Access Compliance Report

Public Rights-of-Way

(Curb Ramps)

Intersection ID: 14442	Main Street: N_SHARON_AMITY_RD	Cross Street: CENTRAL_AV	Location: N
ADA ID: E0EFCDD2C0B7	Ramp Type: Para	Initial Pass/Fail: Pass	Overall Compliance: No
Severity Score: 0.25			
Codes/Mitigation Info/Possible Solution		Field Measurements/Component Compliance

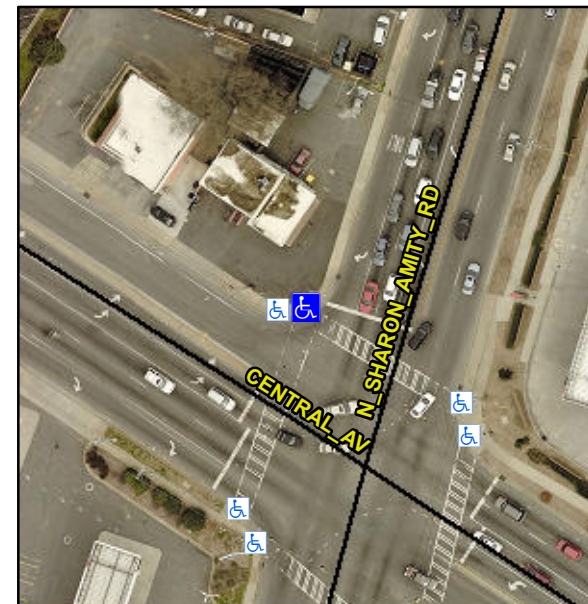
Compliance	Description	Data	Compliance	Description	Data
N/A	Ramp Length LT (in)	53.0	N/A	Ramp Length RT (in)	57.5
Yes	Ramp Width LT (in)	72.0	Yes	Ramp Width RT (in)	60.5
Yes	Ramp Slope LT (%)	5.0	Yes	Ramp Slope RT (%)	6.9
No	Ramp XSlope LT (%)	2.3	No	Ramp XSlope RT (%)	3.3
Yes	Landing Length (in)	72.0	Yes	DWS Provided?	Yes
No	Landing Width (in)	39.0	Yes	DWS Contrast?	Yes
No	Landing Slope (%)	3.3	Yes	DWS Length (in)	25.5
No	Landing X Slope (%)	2.6	Yes	DWS Full Width?	Yes
N/A	Landing Curb? (Y/N)	No	Yes	DWS Offset (in)	2.0
N/A	Shared Landing?	No			
Yes	Gutter Ponding?	No	Yes	Gutter Slope (%)	3.2
Yes	Gutter Lip Ht (in)	0.0	Yes	Gutter X Slope (%)	1.2
N/A	Painted X Walk1?	Yes	N/A	Painted X Walk2?	N/A
	X Walk 1 Direction	To SE		X Walk 2 Direction	N/A
N/A	X Walk 1 Width (in)	103.0	N/A	X Walk 2 Width (in)	N/A
	X Walk 1 Slope (%)	4.2		X Walk 2 Slope (%)	N/A
	X Walk 1 X Slope (%)	0.2		X Walk 2 X Slope (%)	N/A
Yes	Ramp inside XWalk1?	Yes	N/A	Ramp inside XWalk2?	N/A

Road Slope (%)	N/A	N/A	Clear Space?	Yes
	Road X Slope (%)	N/A	N/A	Clear Space to XWalk (in)	N/A
Yes	Any Obstructions?	No	Yes	Storm Grate/Utility Hazard?	No
	Obstruction Type			Storm Grate/Utility Type	
		N/A			N/A
			Yes	Surface Condition? (G/P)	Good
			N/A	Curb Slope (%)	22.4

Remove & Replace Entire Ramp.
